FILE NUMBER: 20-DP-37

SUBJECT: Preliminary Site Plan review for an 18-unit residential development. (1105-1107 S 19 Ave).

APPLICANTS MUST ADDRESS ALL COMMENTS AND FINDINGS AS IDENTIFIED BY MEMBERS OF THE TECHNICAL ADVISORY COMMITTEE BOTH IN WRITING (IDENTIFY PAGE NUMBER OF THE CORRECTION) AND ON THE SITE PLAN (ALL CHANGES MUST BE IDENTIFIED, I.E. BUBBLED).

SP-1.1
OF SHEETS

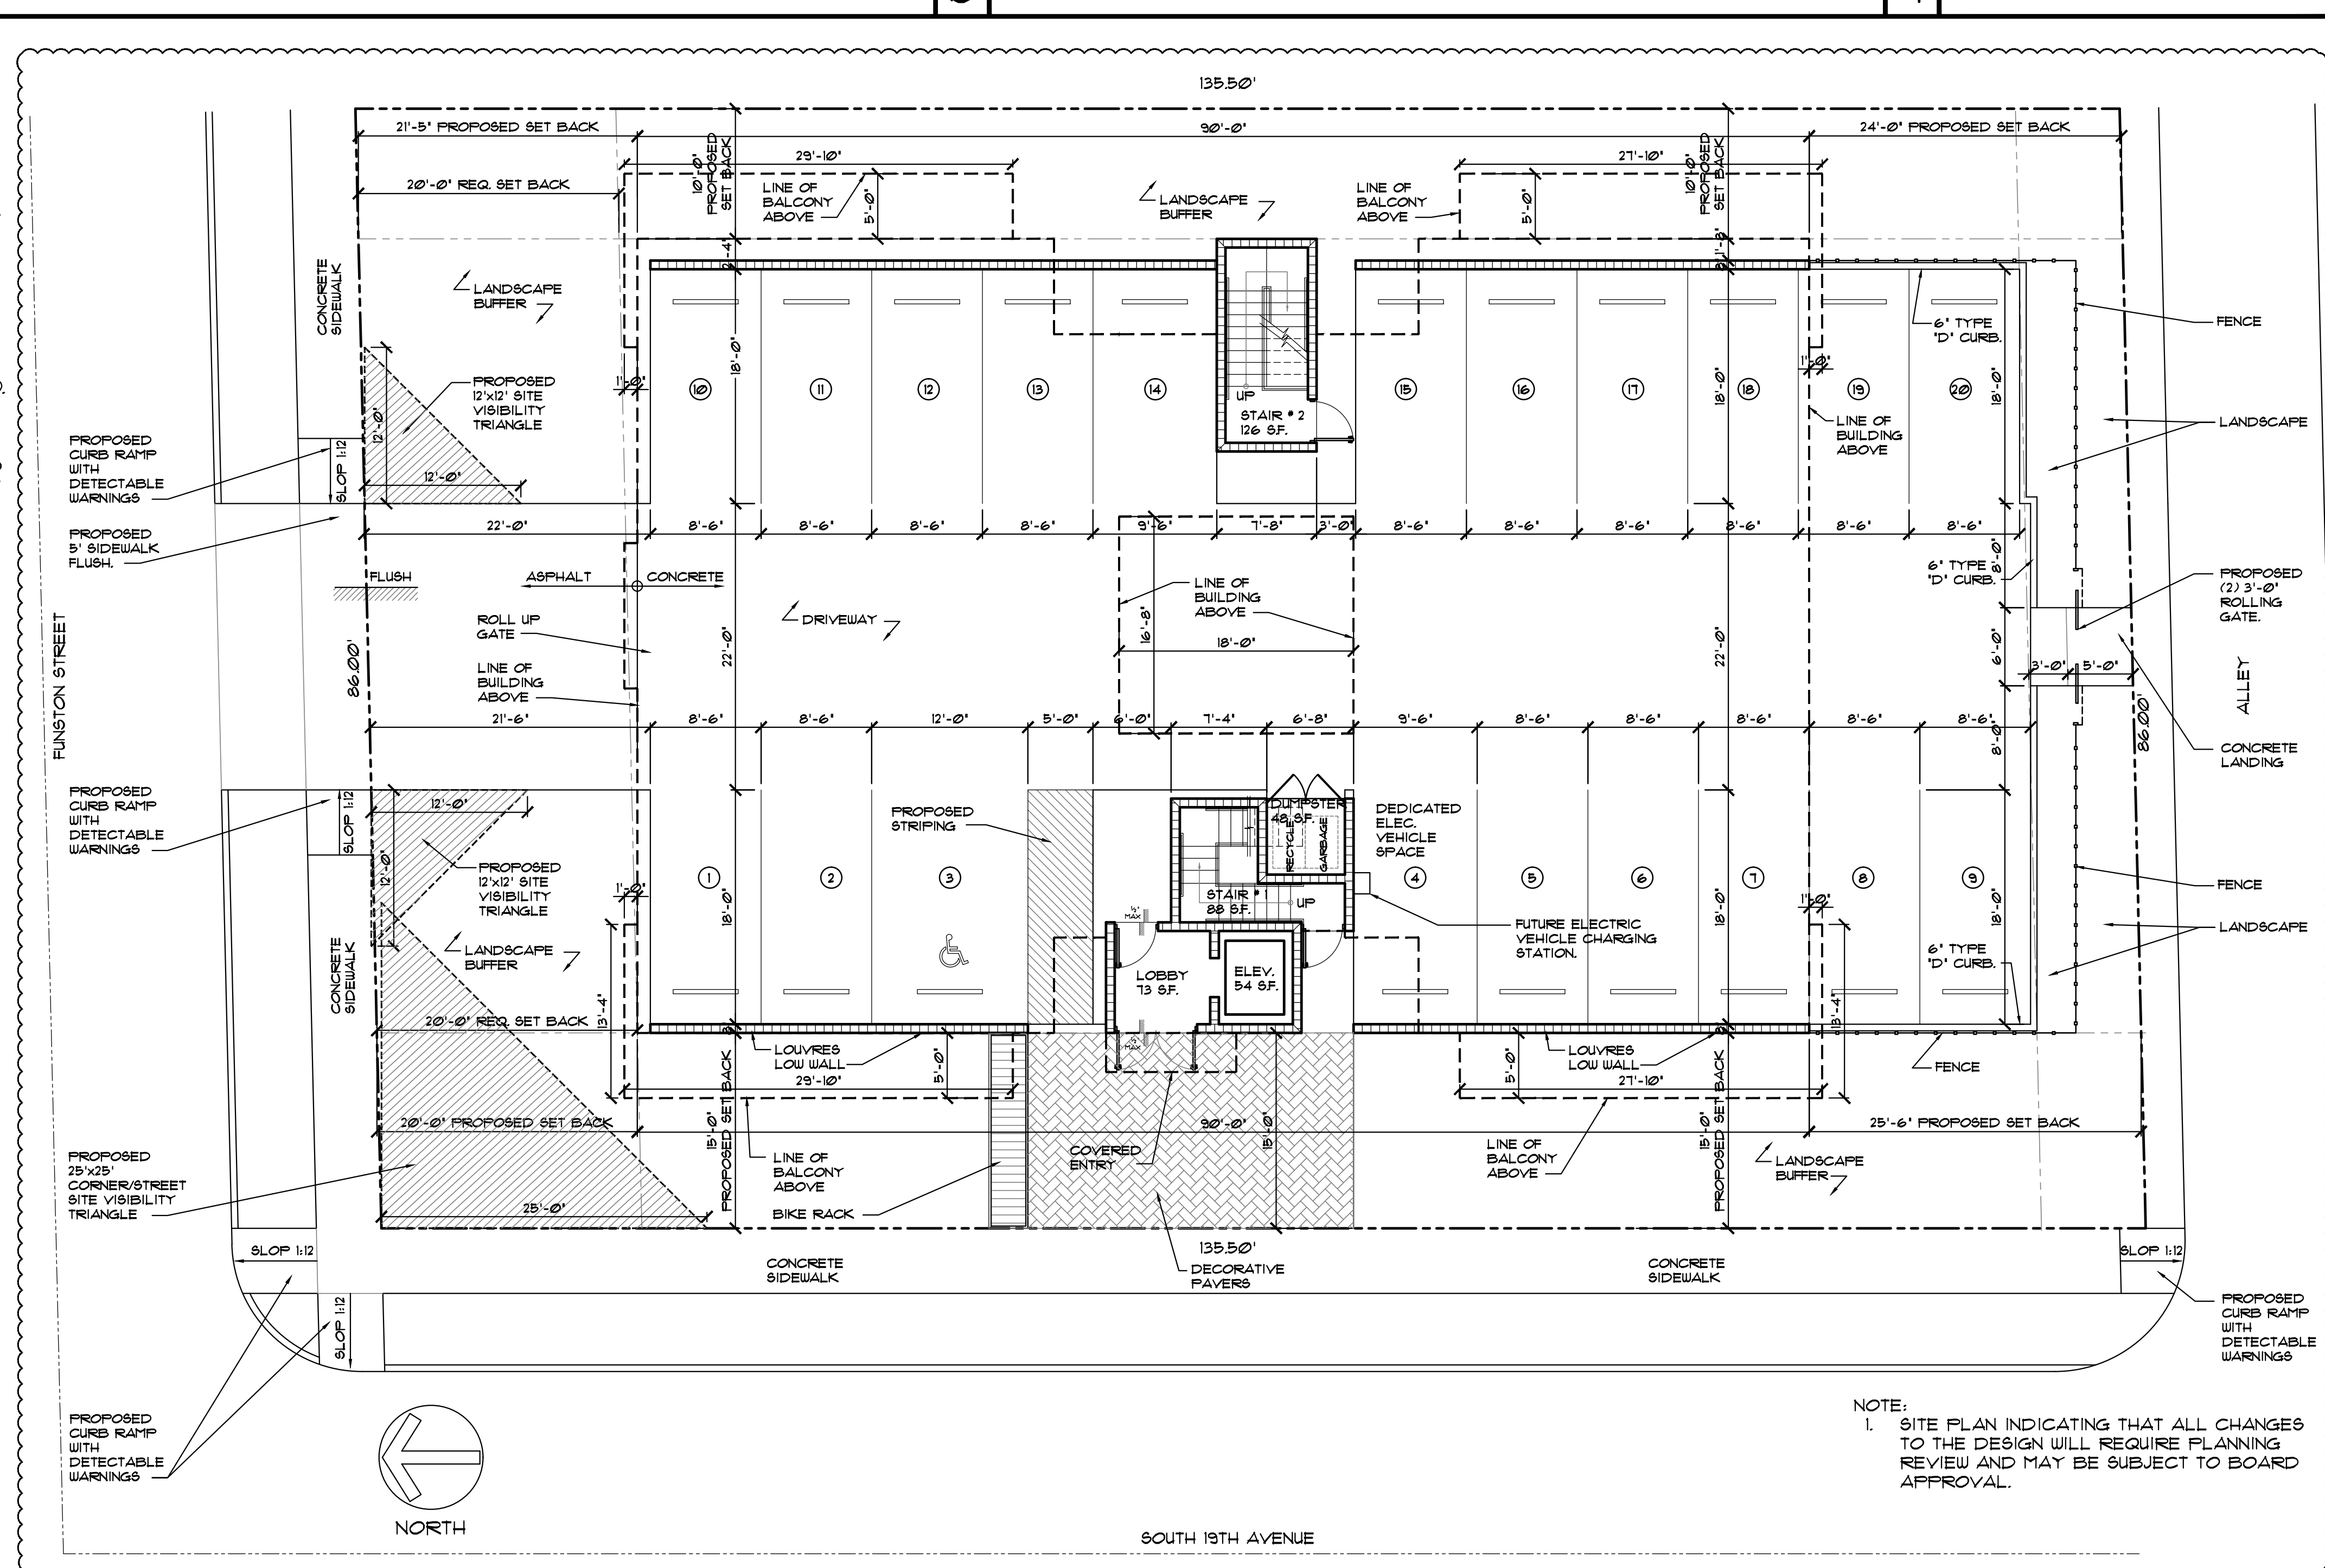
- a. Include note on Site Plan indicating that all changes to the design will require planning review and may be subject to Board approval.

- b. Provide dimensions or balconies and overhangs above.

1. Minimum required rear setback for the at-grade parking is five feet. Revise accordingly.

5. Parking stall 8 does not meet the minimum width requirements. Revise accordingly.

1. Include note on Site Plan stating the maximum foot-candle level at all property lines (maximum 0.5 allowed).

1. As per the green building ordinance in Chapter 151, the project must include at least ten green building practices since this project has less than 20,000 square feet of total floor area. Include this list on the site plan. (See 151.150-151.160)

Response: Refer to SP-1.1 note was added

Response: Refer to SP-1.1 dimensions were added

Response: Refer to SP-1.1 showing updated table

Response: Refer to SP-1.1

Response: Added note on SP-1.1

Response: Refer to SP-1.1 showing 10 green building practices we are using.

1 DUMPSTER ENCLOSURE DETAIL
SCALE: 1/4" = 1'-0"

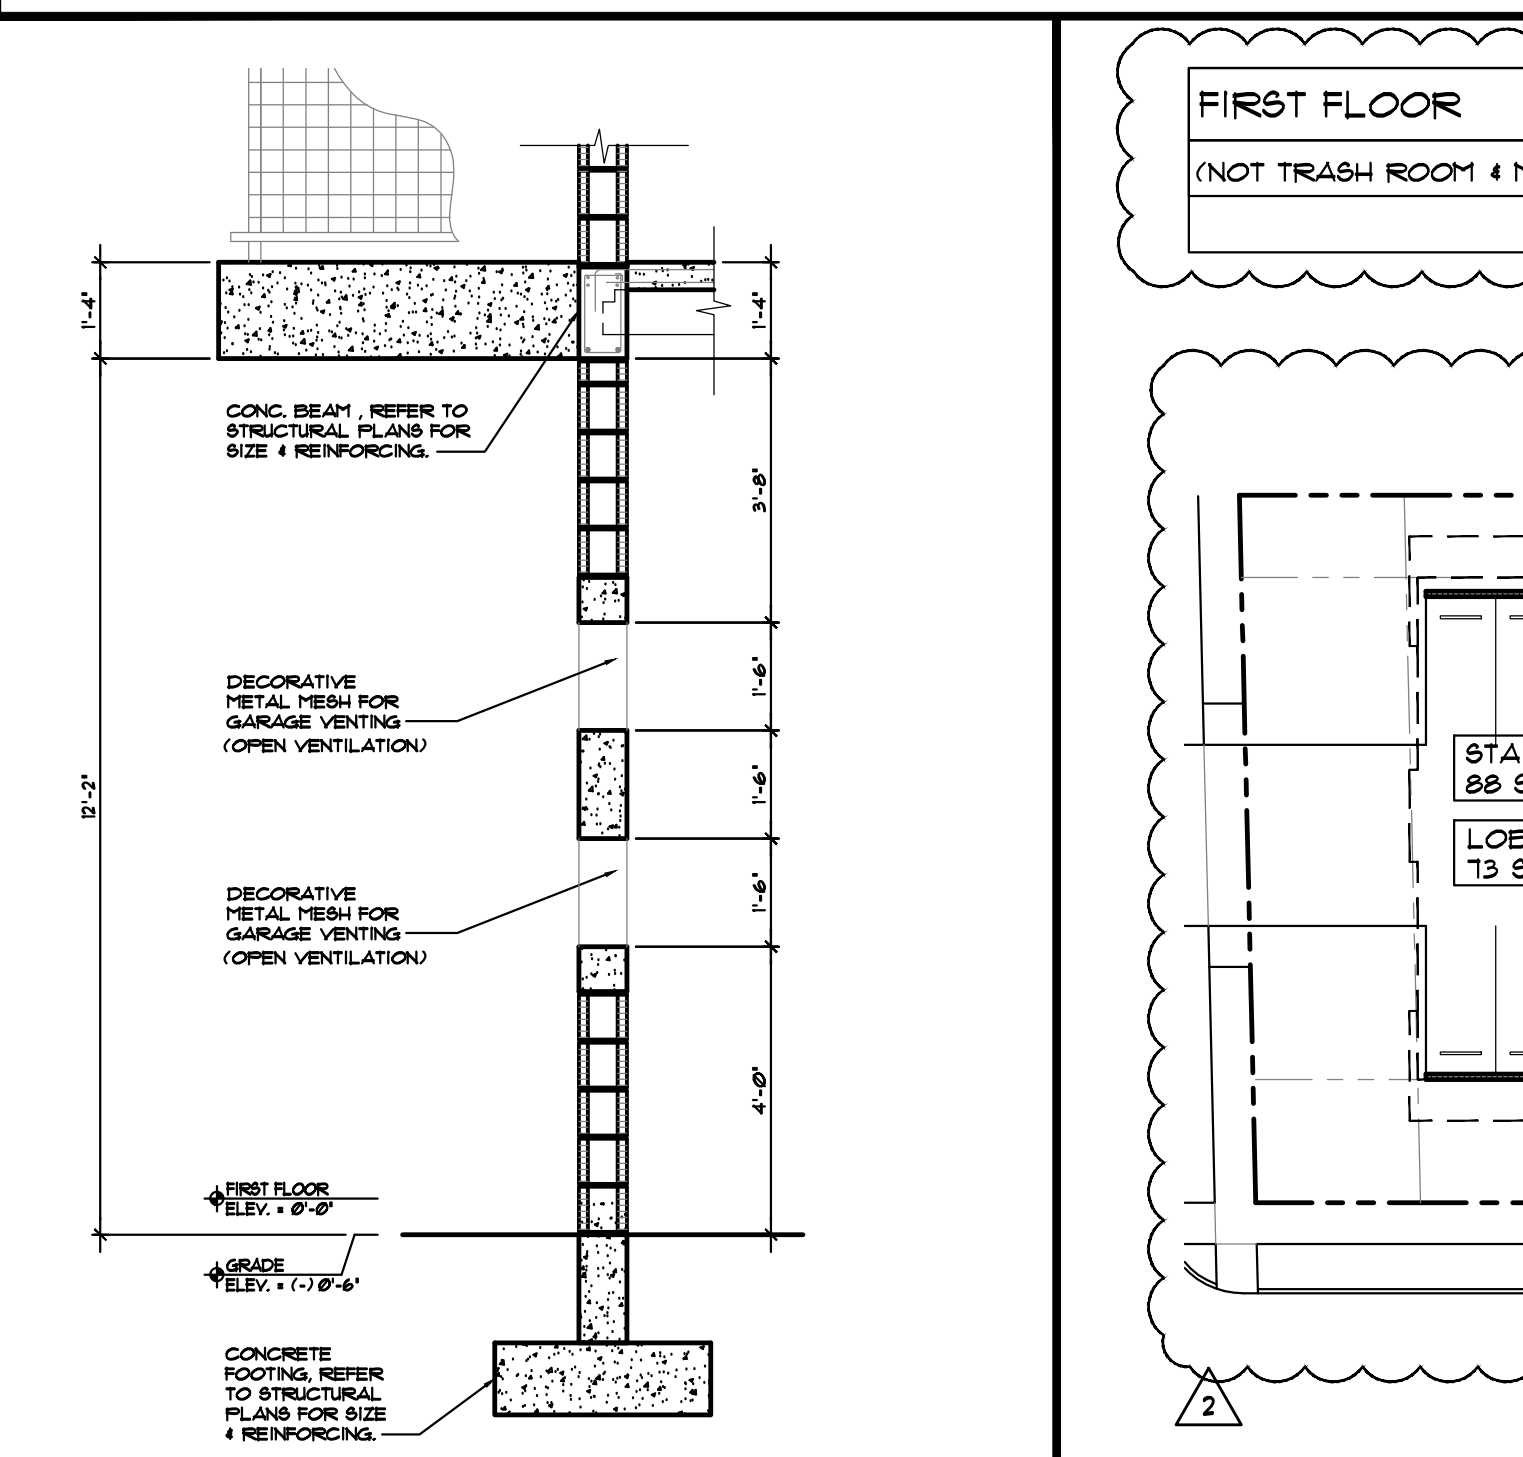
- e. Dumpster enclosure details do not correspond to site conditions.

Response: Refer to SP-1.2 detail was updated to meet site condition

8 DIAGRAM (F.A.R. CALCULATIONS)
SCALE: N.T.S.

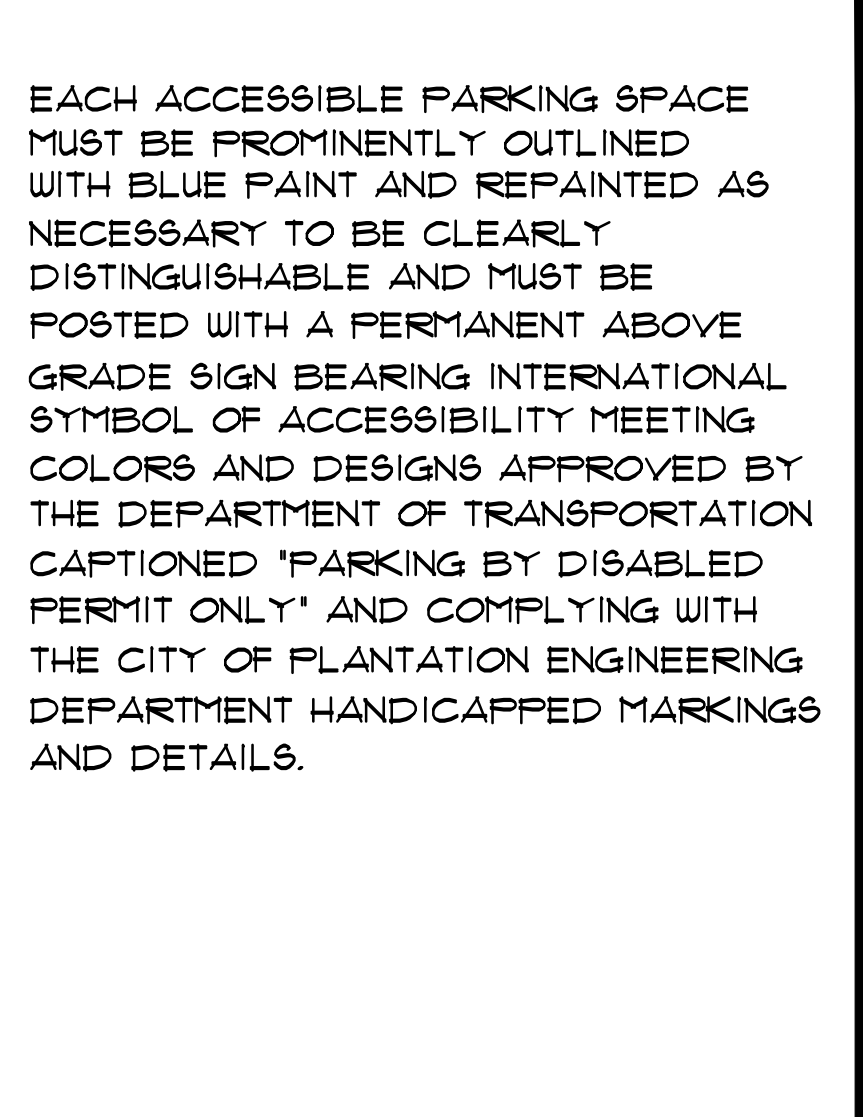
2. Provide FAR diagrams to depict calculations. Circulation area within courtyard shall be included in calculations.

Response: Refer to SP-1.2 showing diagram and calculations. Please note that as per code unenclosed exterior terraces, breezeway or porches which provide access to units are not part of F.A.R.

9 DIAGRAM (PERVIOUS & IMPERVIOUS)
SCALE: N.T.S.

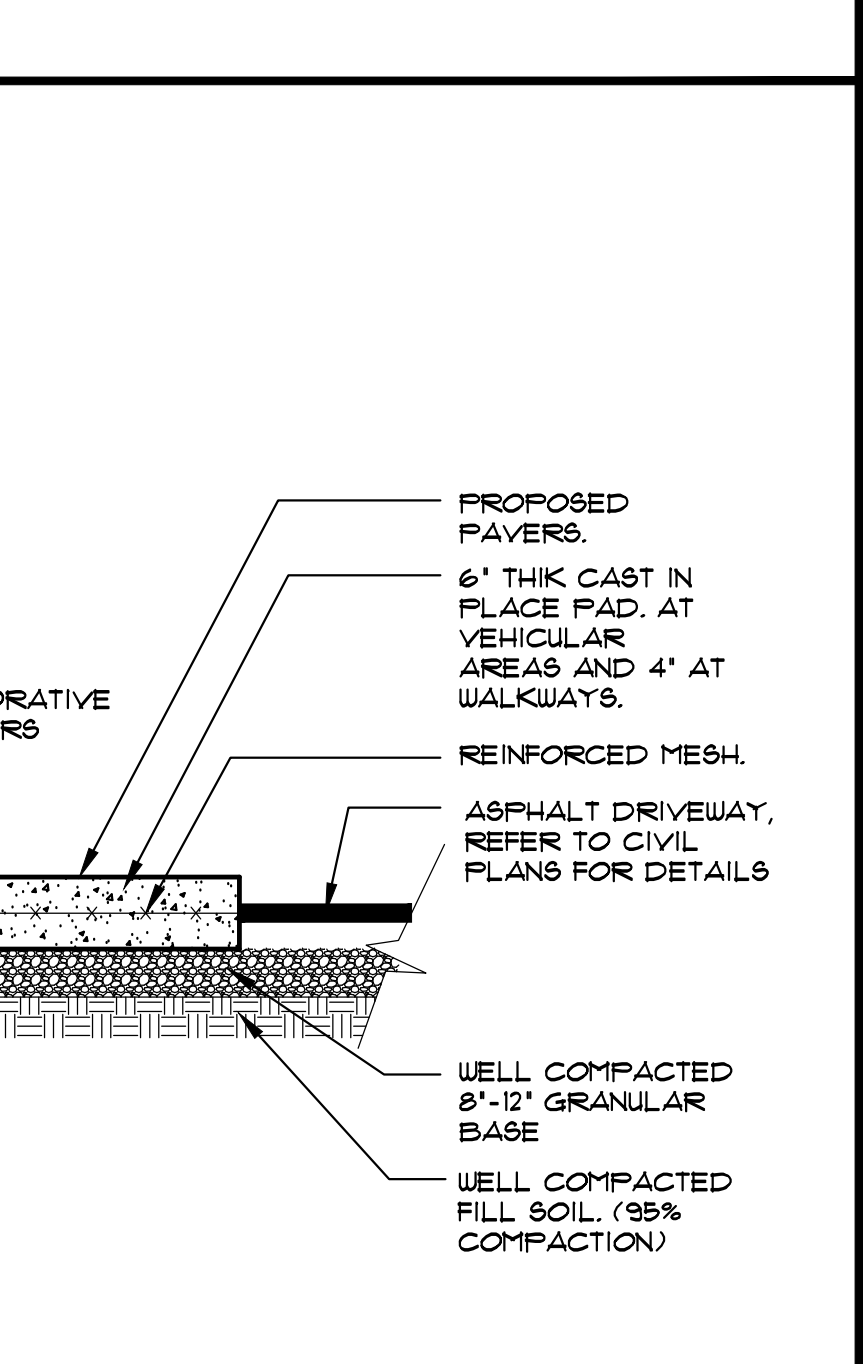
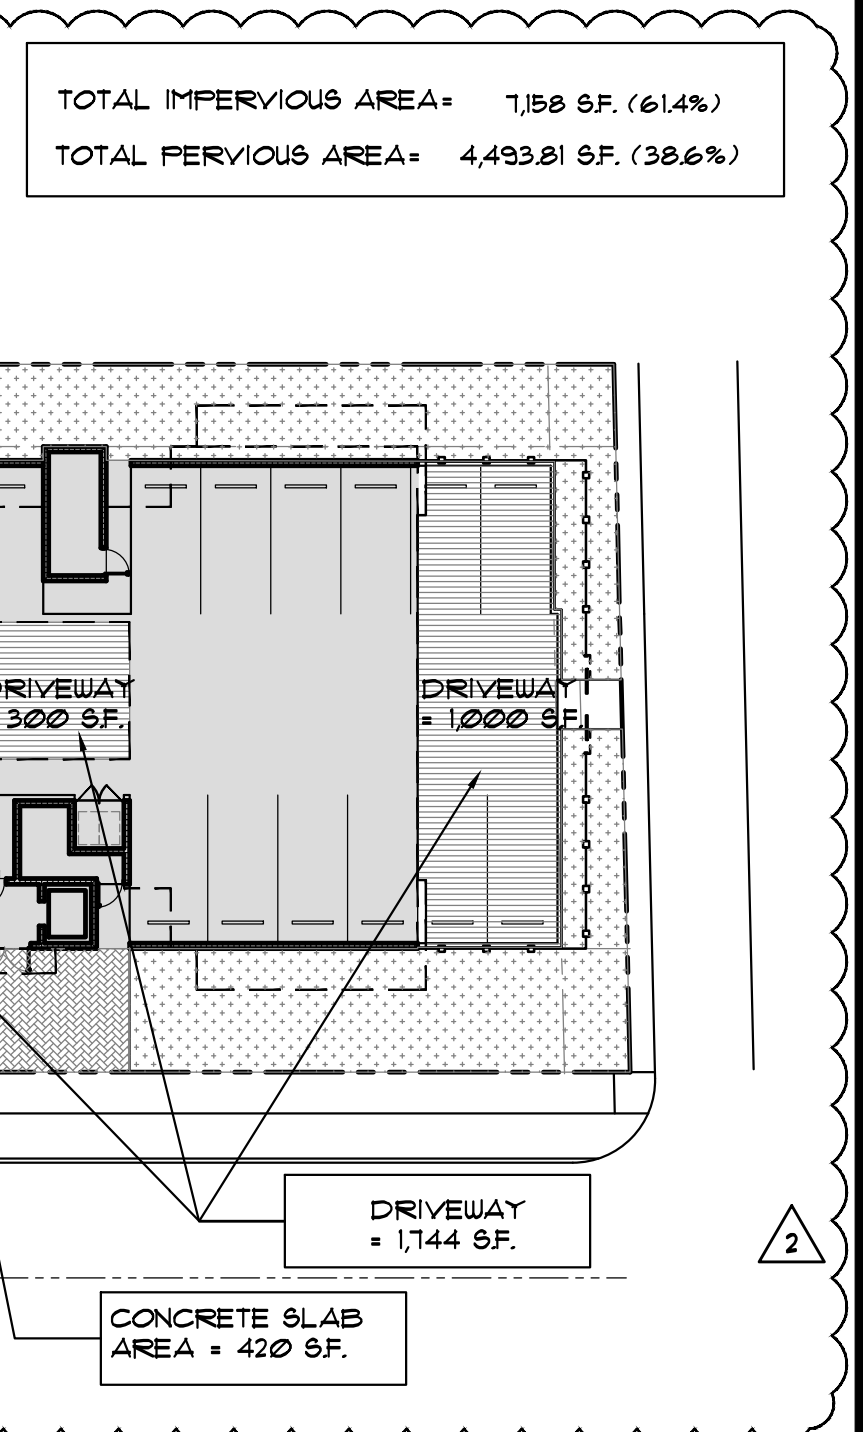
6. Provide required and provided amounts for pervious and impervious in square footage, acreage and percentage for vehicular use area. Include calculations where necessary.

3. Diagram depicting areas accounted for in the calculation of the vehicular use area does not indicate required landscape area. Lots with a width 50 feet or more require 25 percent of the total square footage of the vehicular use area shall be landscaped. (Note: Percentage calculations excludes required perimeter landscape setback area). Revise accordingly.

Response: Refer to SP-1.1 and SP-1.2 site data was revised.

Response: Refer to diagram on SP-1.2
